**Re: Request for Access to Information Under Part II
of the Access to Information and Protection Privacy Act**

Project: Glencrest-Galway Development – Application for Re-zoning
Project No.: PN 10003

Re: Glencrest/Galway – Response to Staff Comments

TRANSPORTATION PLAN

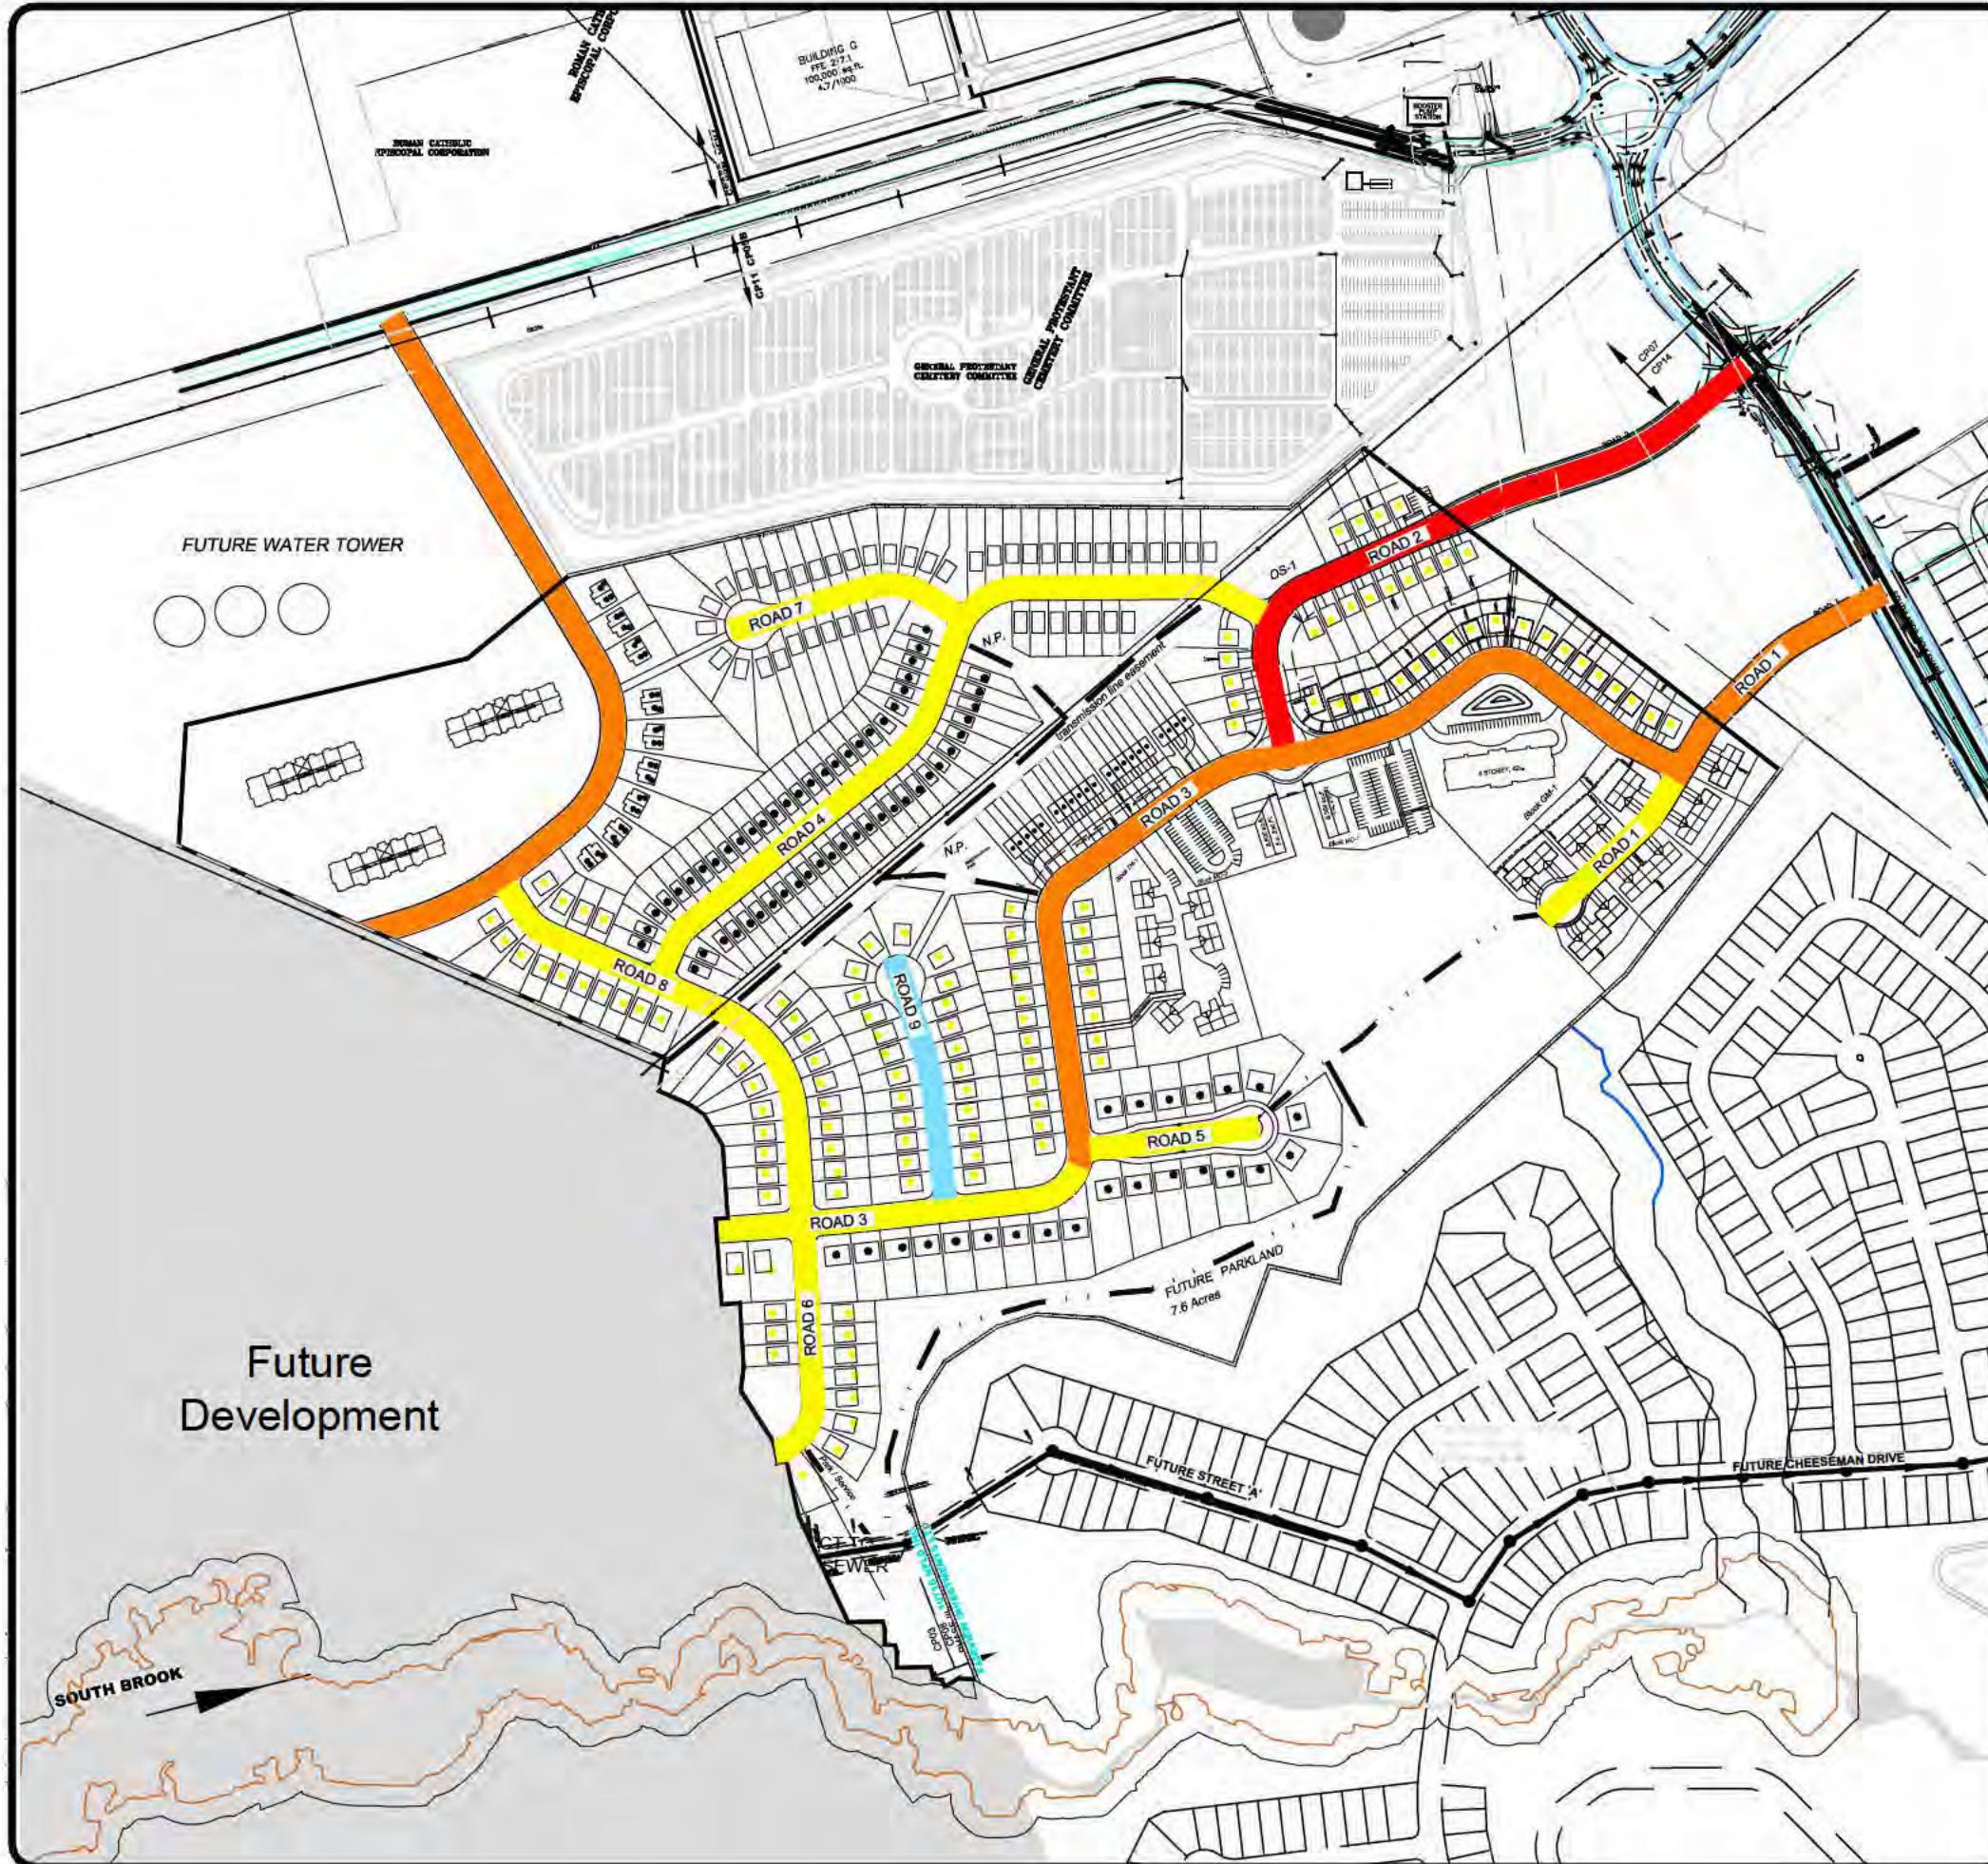
16. The intersection of "Road 3" and "Road 5" is improperly designed and needs to be reconfigured. The current designation of the roadways along with the end treatment and change in designation of "Road 3" results in the main flow of traffic performing turning movements at an intersection. This can be eliminated by continuing the main roadway and altering the cul-de-sac to intersect with the main travel way. The current design encourages non-compliance to the traffic control and invites collision problems. **This intersection has been redesigned accordingly.**

17. The junction of the Residential Collector Road and Road 7 is improperly designed. The "Residential Collector Road" should be continuous as this is one of the main thoroughfares. The alignment should be altered to maintain the continuous flow/alignment of the collector with "Road 7" altered to intersect and form a T intersection. **The road configuration has been revised accordingly.**

18. The current network layout does not appear to be transit friendly. This issue will be referred to the St. John's Transportation Commission (Metrobus Transit) for review. Please note that approved Metrobus transit routes do not necessitate sidewalk clearing by the City of St. John's. **We understand this has not yet been reviewed in detail with respect to transit. We would like to review with the appropriate staff.**

Please note that the proposed collector Road #10 has been reconfigured to provide direct routing to the water tower connector road. This has necessitated reconfiguration of the adjacent local streets (Road #7). We are comfortable with these changes.

GALWAY ROAD CROSS SECTIONS

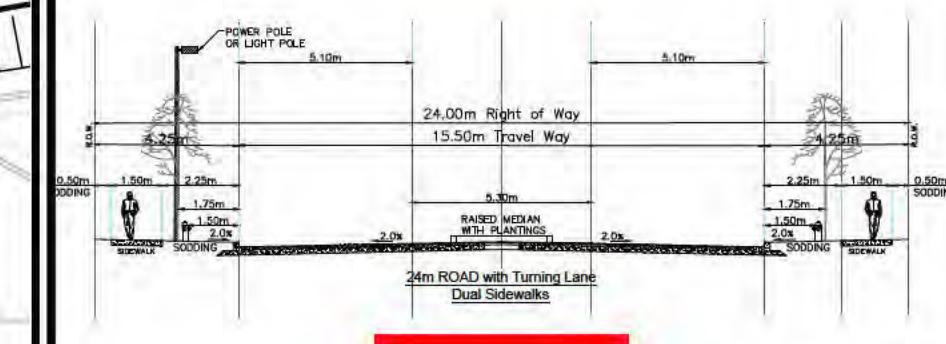
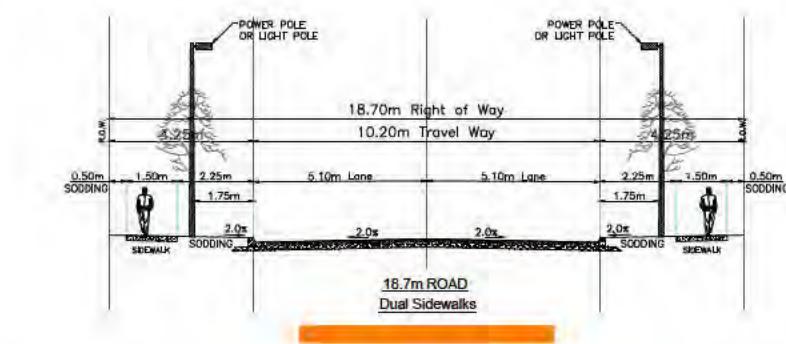
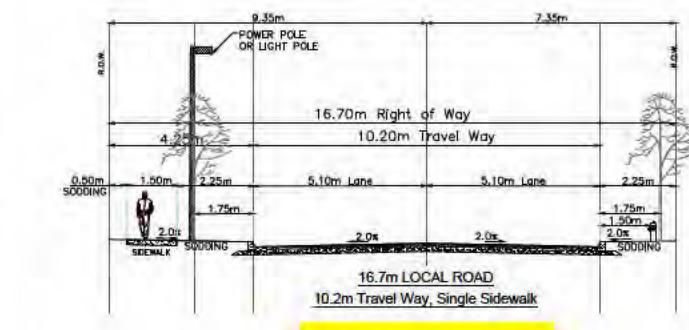
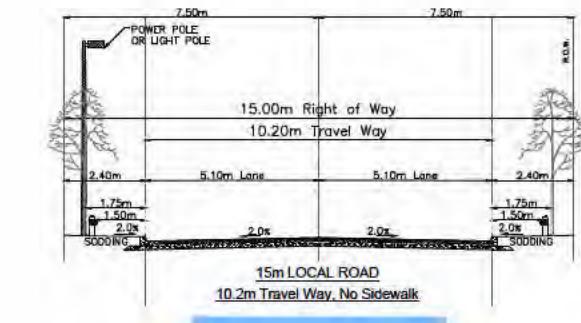
1. On-street parking is required on both sides of the proposed local roads. The proposed 10m travel way must be increased to a width of 10.2 m. **Agree – please see revised plans.**
2. The developer must be aware that the proposed boulevards with sodding are likely to be damaged during winter maintenance. *[Due to budget implications, this issue will need to be discussed with council prior to final approval]*. In all instances, trees must be planted behind the sidewalk. **The proposed boulevards are an important feature for the Galway development that will set it apart from others and help in making it a success. We believe that maintenance costs are not significant in the context of the overall snow clearing budget and would be a small concession to achieve this improved streetscape.**

8. Further details are required about the proposal for Road 2 (red as shown on Schedule D), particularly with respect to the proposed central boulevard. To provide appropriate space to support tree growth, the boulevard must be a minimum of 5 m in width. Trees can be planted no closer than 2.5 m from the face of curb. Should the developer wish to maintain a more narrow boulevard, alternate plantings would be required. The Developer should provide some details for review by the City’s Parks and Open Spaces Division. Regardless, road speeds must be limited to 50 km/hr. **Agreed – plan has been revised and ready for additional comment.**

19. Road 2 has a different cross-section in Schedule "D" and Schedule "E". **Revised**
20. During the phasing of the residential development temporary turn arounds will be required. These must maintain a minimum radius of 15.25 m and will require 50 mm asphalt with appropriate subgrade and granular materials. **Understood – would like some flexibility where work has to be stopped for the winter period, to be continued in the spring.**

A series of revised cross-sections has been provided for your consideration. Please note that each cross section has sufficient room for parking on both sides of the street. We have also enlarged the proposed median to 2.25 meters. Power poles and street trees will be planted not closer than 1.75m from the curb leaving adequate separation from the sidewalk.
